Discretionary Review Abbreviated Analysis

Date: September 12, 2016
Case No.: **2015-014114DRP**
Project Address: **245 Euclid Avenue**
Permit Application: 2015.10.02.8734
Zoning: RH-1 (Residential, House, One-Family)
40-X Height and Bulk District
Block/Lots: 1069/035
Applicant: Tai Ikegami
Feldman Architecture
1005 Sansome Street, Suite 240
San Francisco, CA 94111
Staff Contact: Chris May – (415) 575-9087
christopher.may@sfgov.org
Recommendation: **Do not take DR and approve as proposed**

A3.2
SHEET

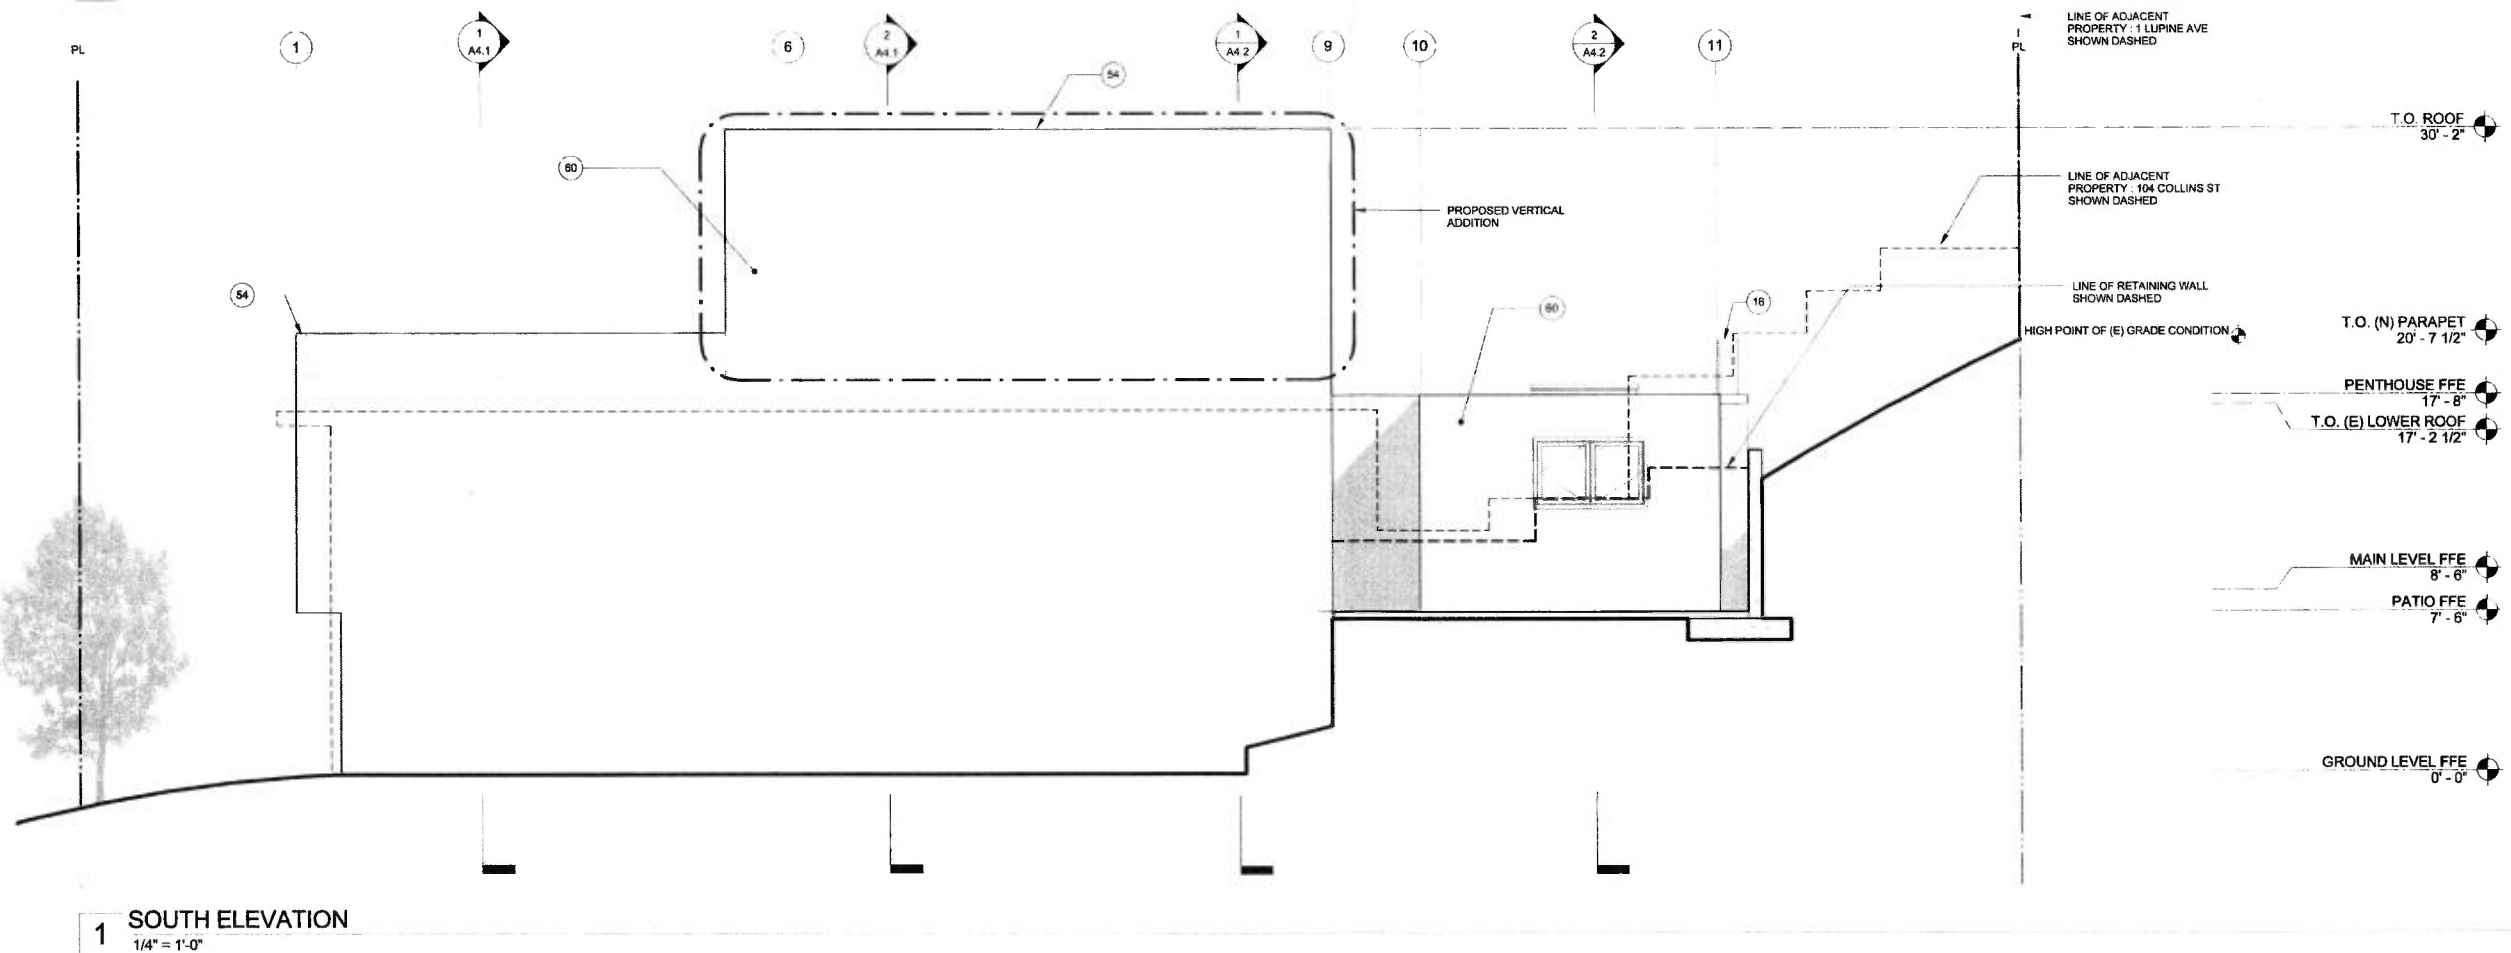
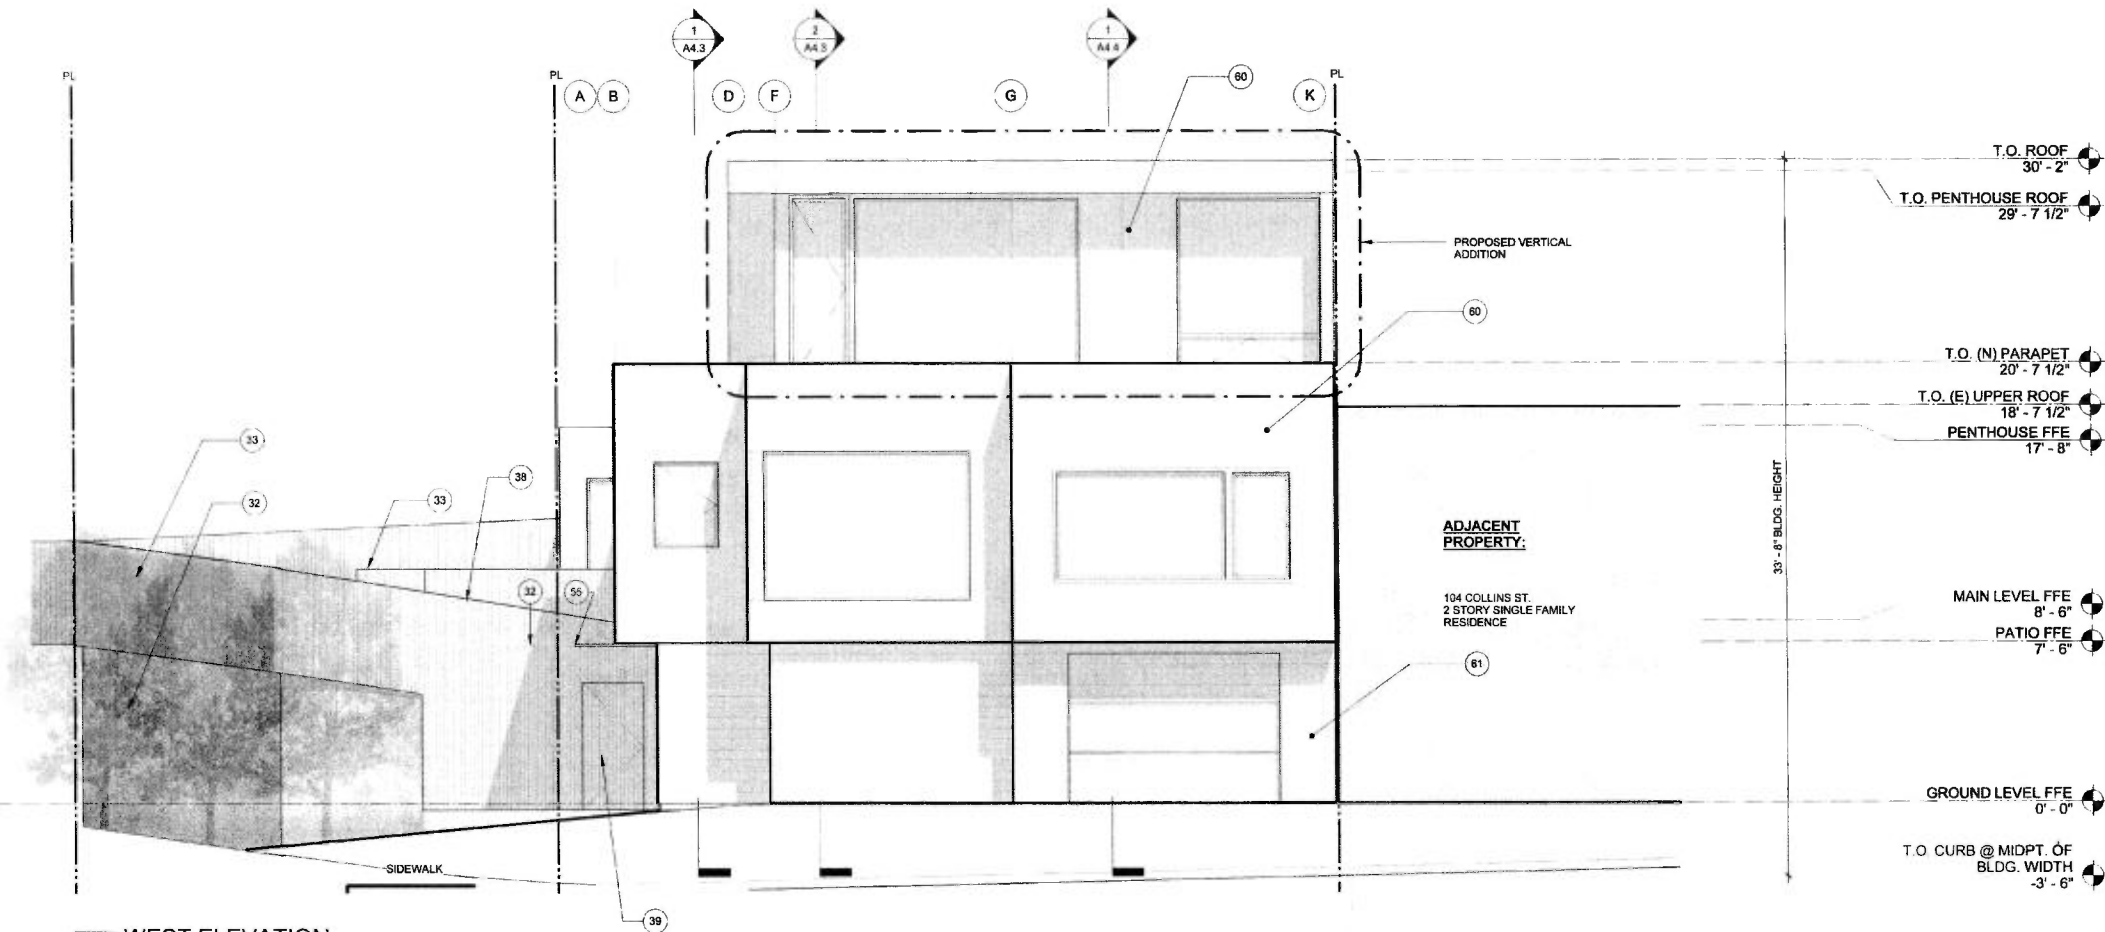
2. Alternatively, require any fence over elevation 8-feet, 6-inches (second story floor) to be of an *open design* to avoid obscuring the second story facade of this prominent corner building. Such open design should be required on: (i) the two new wooden board fences shown on Sheet A3.2, if allowed, and (ii) the new property line retaining wall/fence, if allowed, contrary to this objection. (Ex. A, Sheets A3.2)

The proposal would also add two new wooden board fences that would wrap around the back of the new retaining wall/fence and extend to the front of the building. (Ex. A, Sheet A3.2) The combination of the new retaining wall/fence at property line, the two new wooden fences, and the new wooden siding to be added to the Collins Street frontage, would create the appearance of an unsightly band of solid wall that wraps around the building. (Ex. A, Sheet A3.2) A new gate to the patio would be installed in one of the new fences. (*Ibid.*)

The Commission should grant discretionary review and interpret these concepts to preclude walling off the Euclid Avenue facade of this corner building with a giant, solid wall combined with fences. The portions of all fences higher than elevation 8-feet, 6-inches (second story floor) should be required to be of an *open design* to avoid obscuring the second story facade of this prominent corner building. Such open design should be required on: (i) the two new wooden board fences shown on Sheet A3.2, if allowed, and (ii) the new property line retaining wall/fence, if allowed, contrary to this objection. (Ex. A, Sheet A3.2)

The subject building and the adjacent two buildings on Collins Street have stucco facades and exhibit a strong modern architectural pattern. (Ex. D, photos) However, the proposal would change a portion of the Collins Street facade of 245 Collins from stucco to horizontal wooden siding. (Ex. A, Sheet A3.2)

The proposal would add a third story that would clash with the common rooflines and shatter the composition of the streetscape. (Ex. A, Sheet A3.2) Therefore, the third story should be eliminated to maintain the group of buildings that have common rooflines on this prominent corner.

A3.1
SHEET

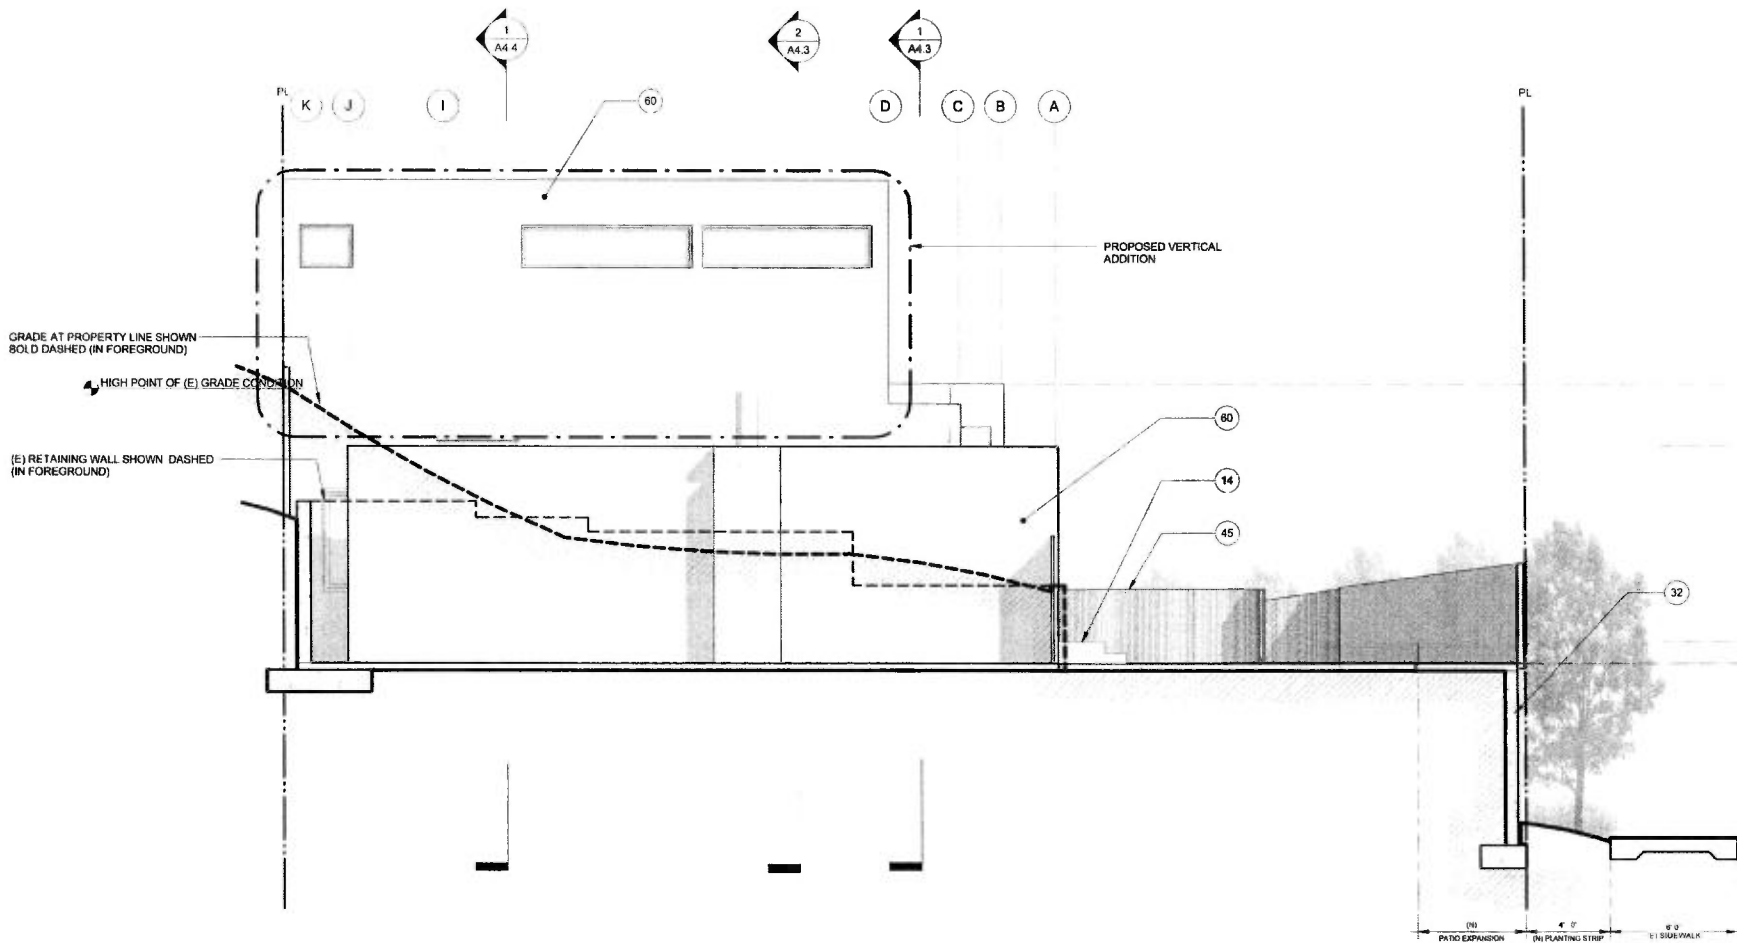
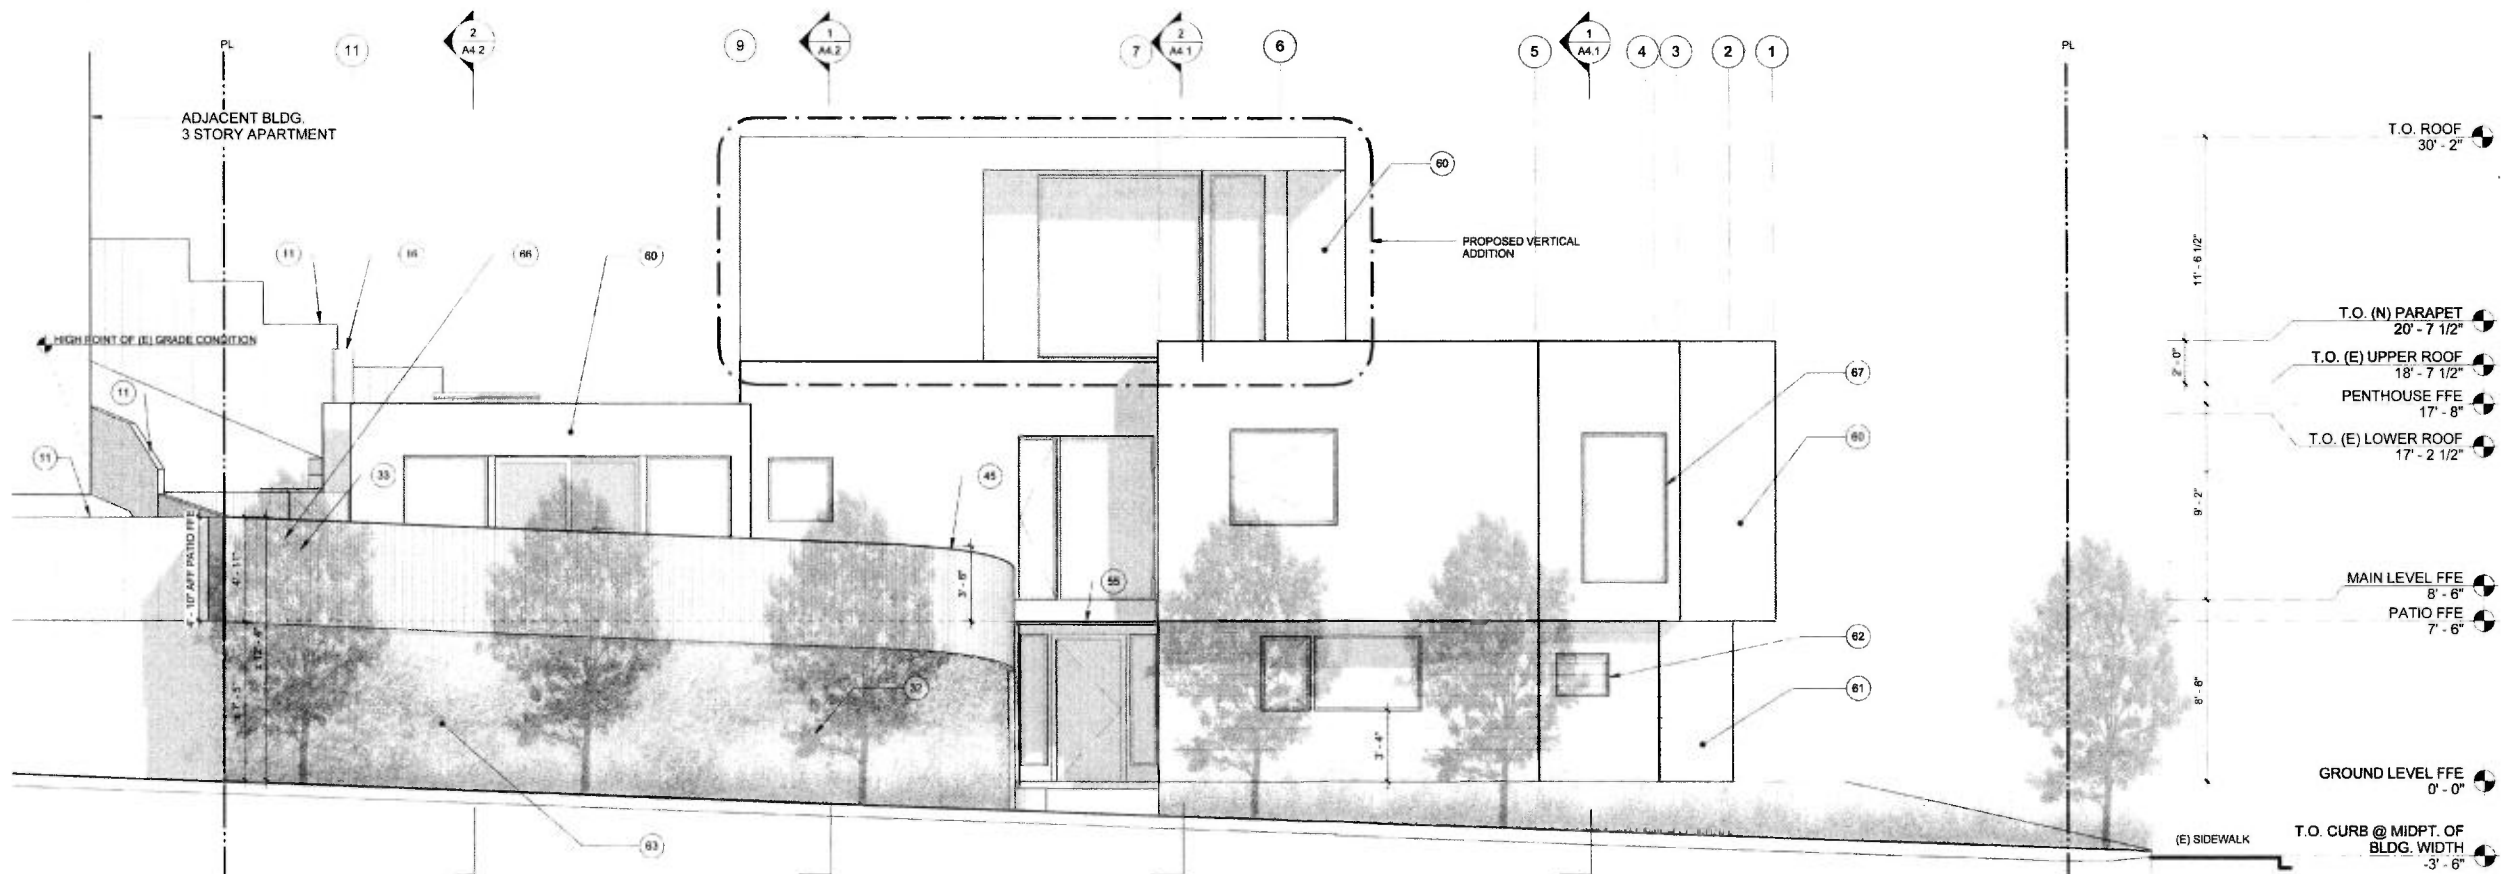
The proposed 12-foot, 4-inch tall new concrete retaining wall (7'-5" tall or 89 inches tall) topped with wooden fence (4'-11" tall or 59 inches tall) at the Euclid Avenue property line would result in an ugly, solid wall that would obscure the Euclid Avenue facade of this corner building and overwhelm the Euclid Avenue block frontage. (Ex. A, plan excerpts, Sheets A0.0, A3.1)

If a Variance for a new retaining wall/fence and patio extension into the rear yard is granted, the Commission should grant discretionary review and eliminate the new wall/fence or reduce the height of the new wall/fence to 8'-6" (second story floor) or 8'-3" (adjacent wall/fence height at border with 1 Lupine). (Ex. A, plans, Sheet A3.1)
